Rancho Buena Vista High School – Fire Alarm Upgrade

Vista Unified School District

ADDENDUM No. 1

Bid #V24251167B April 23, 2025

1 SITE PLAN - FIRE ALARM
SCALE 1"=50'

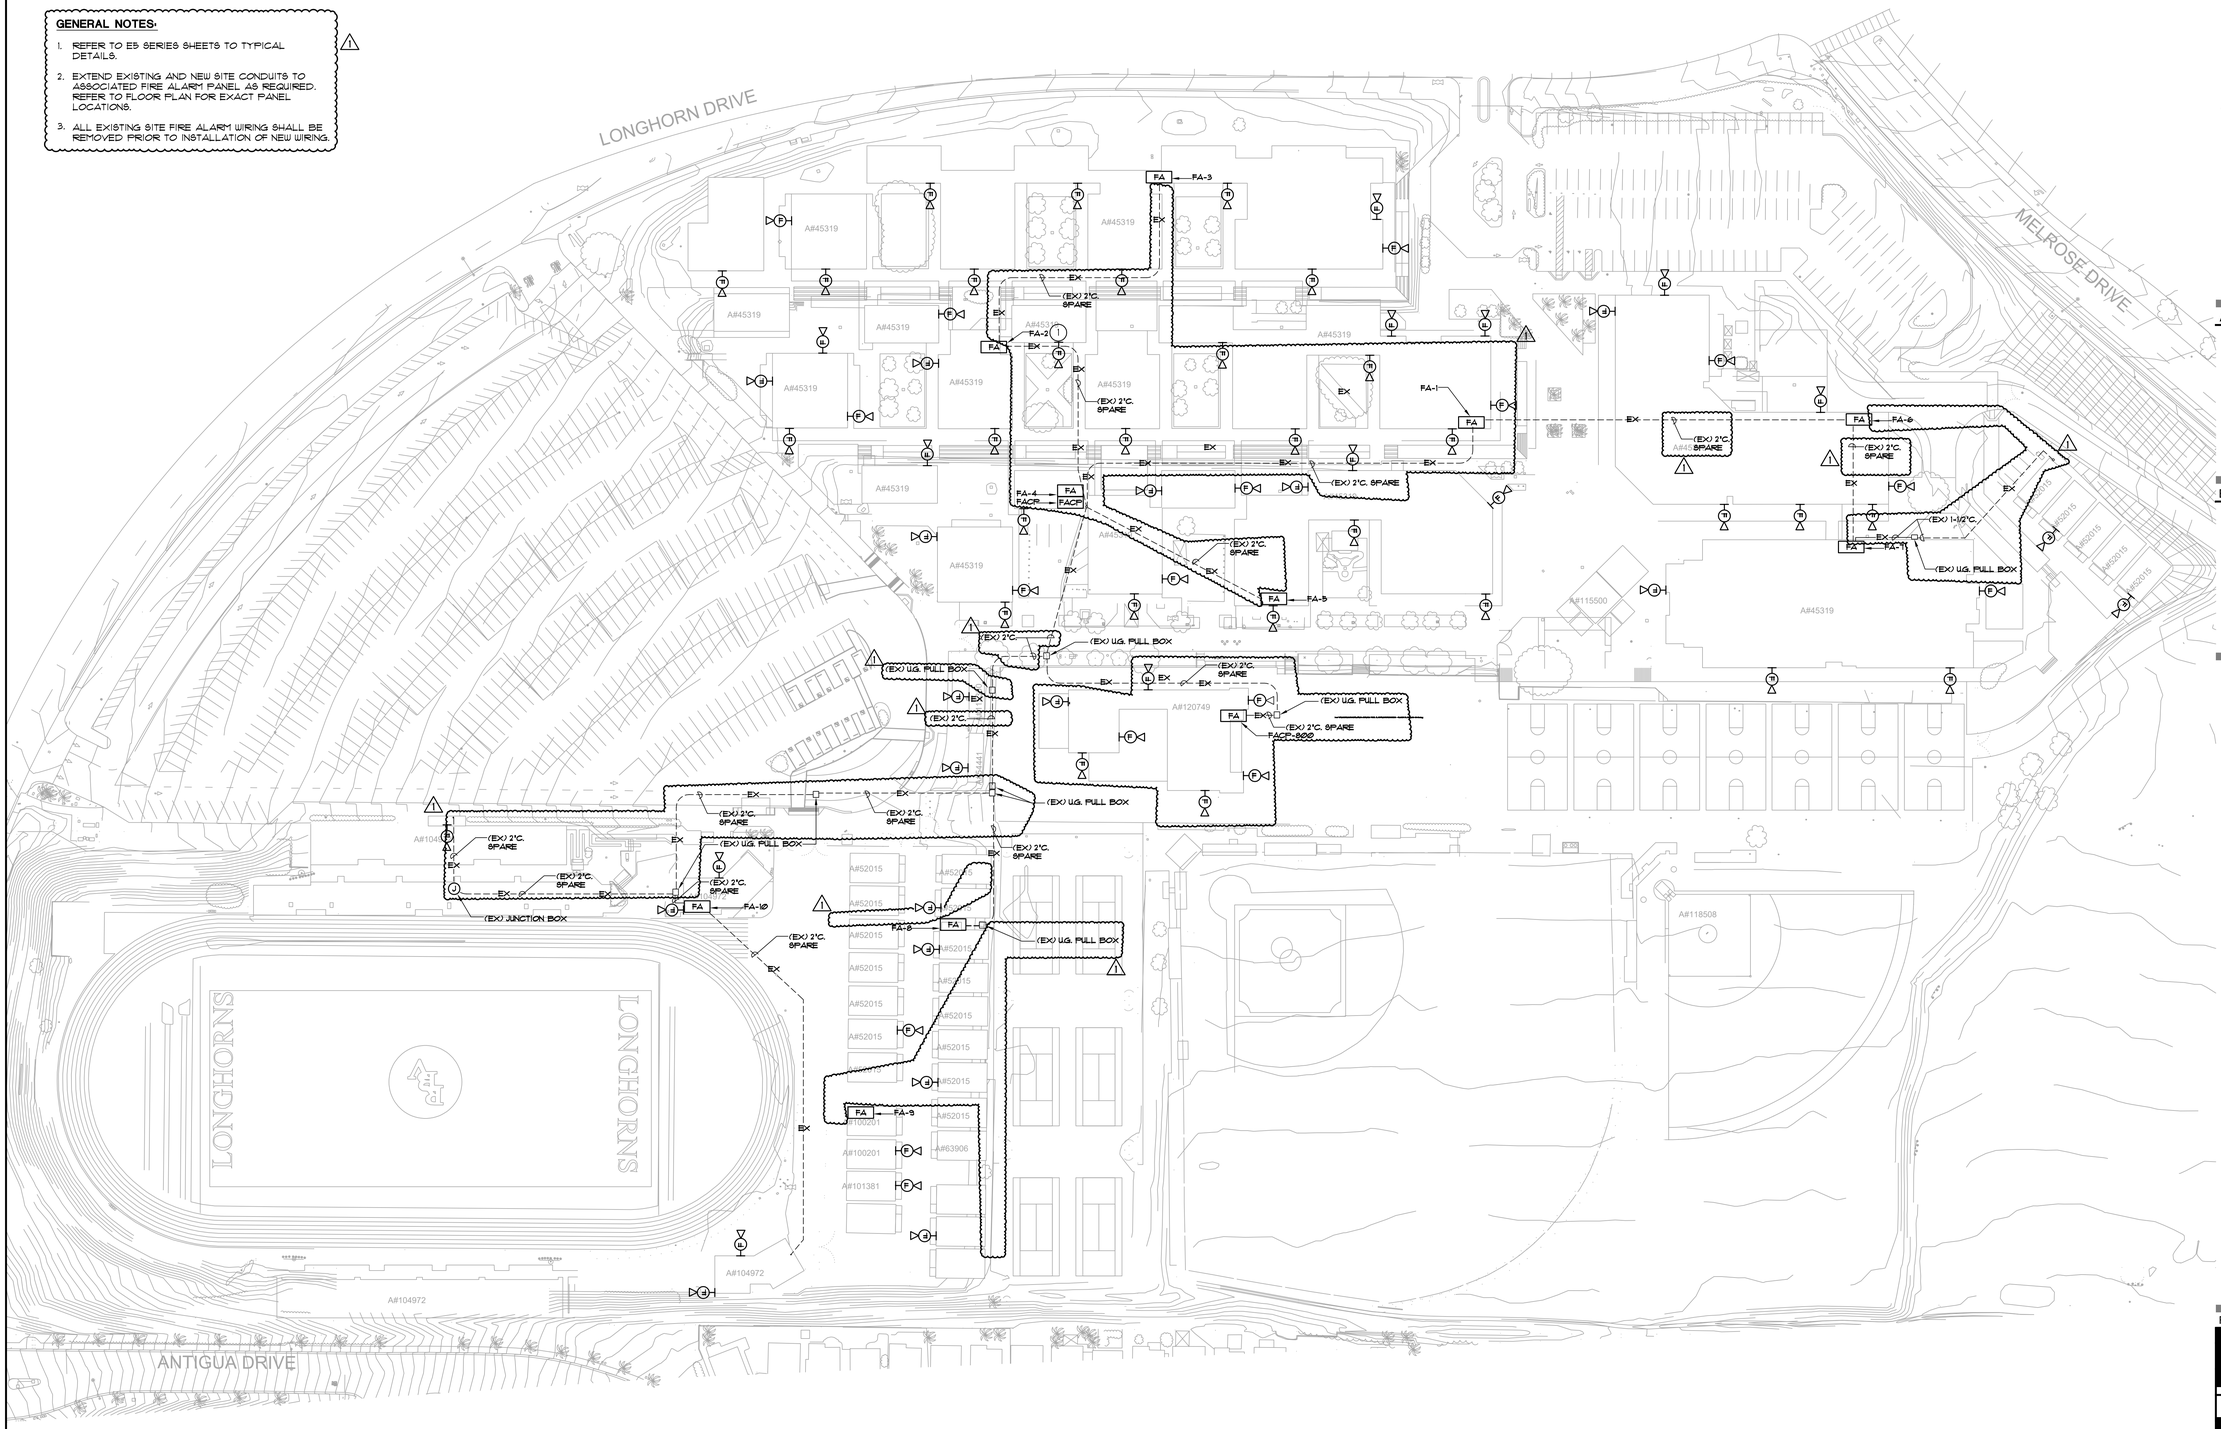
Item #2. REVISION – Site Plan - Fire Alarm E-5.0
- a. Revised existing fire alarm routing on site plan.

DAMPER/HVAC UNIT FIRE ALARM CONTROL DIAGRAM — 1 / E5.21
NO SCALE

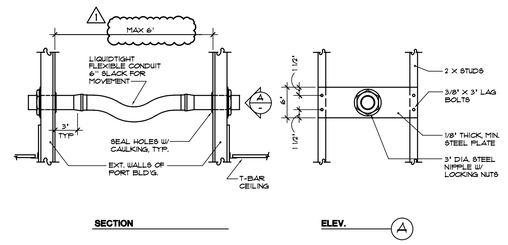
Item #23. REVISION – Typical Details E-5.21
a. Revised detail 1 for clarity.
b. Omitted detail 4.

1 DEMOLITION PLAN - FIRE ALARM
SCALE: 1/8" = 1'-0"

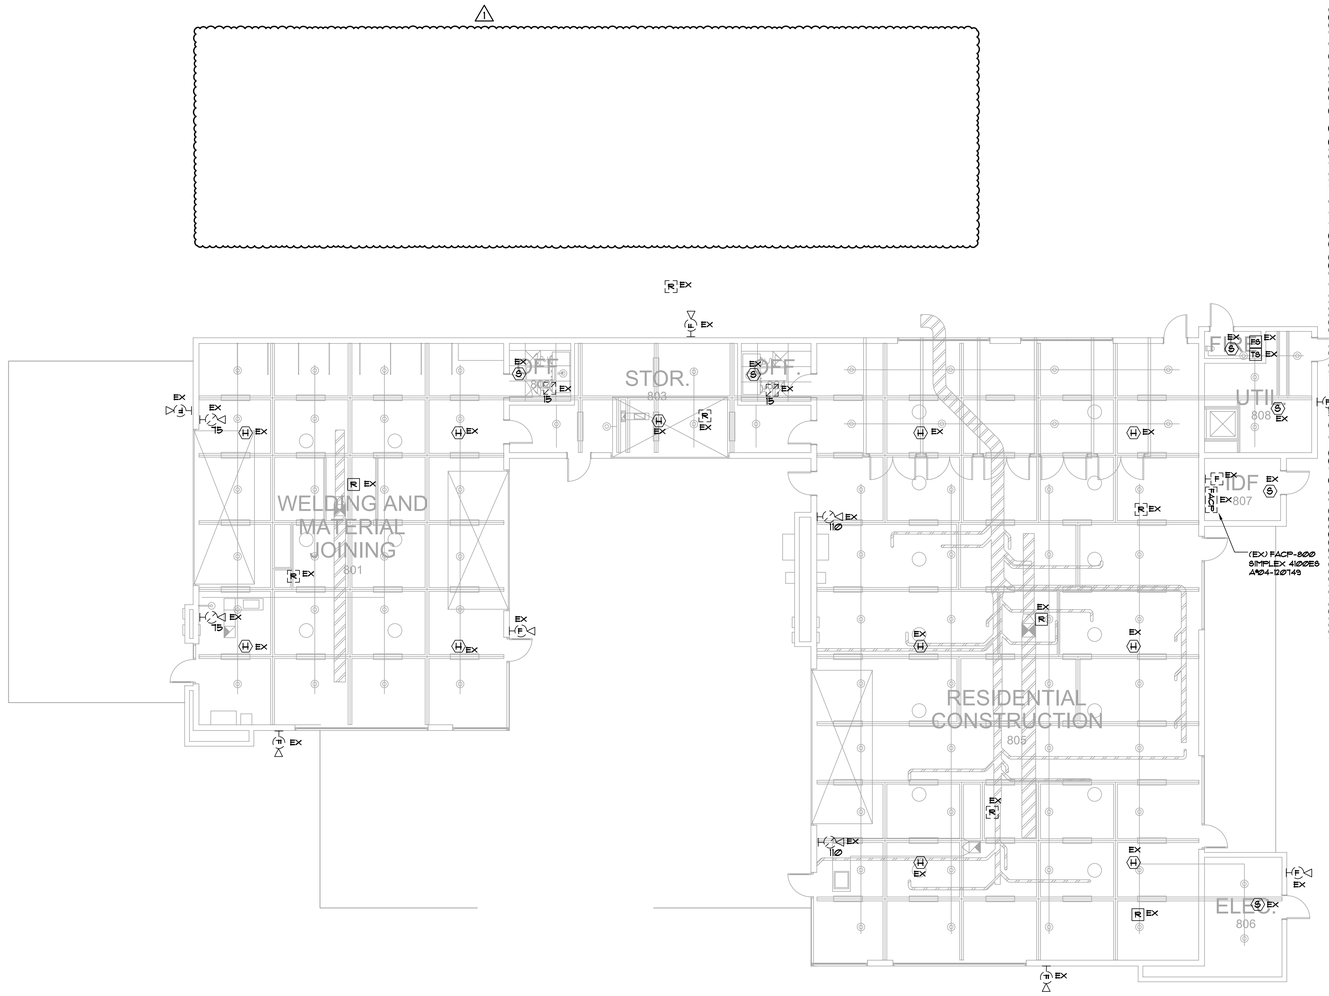
Item #25. ADDITION – Demolition Plan - Fire Alarm E-10.9
a. Provided "Demolition General Notes", "General Demolition Requirements", and "Fire Alarm Symbols Legend to be Removed" on sheet.
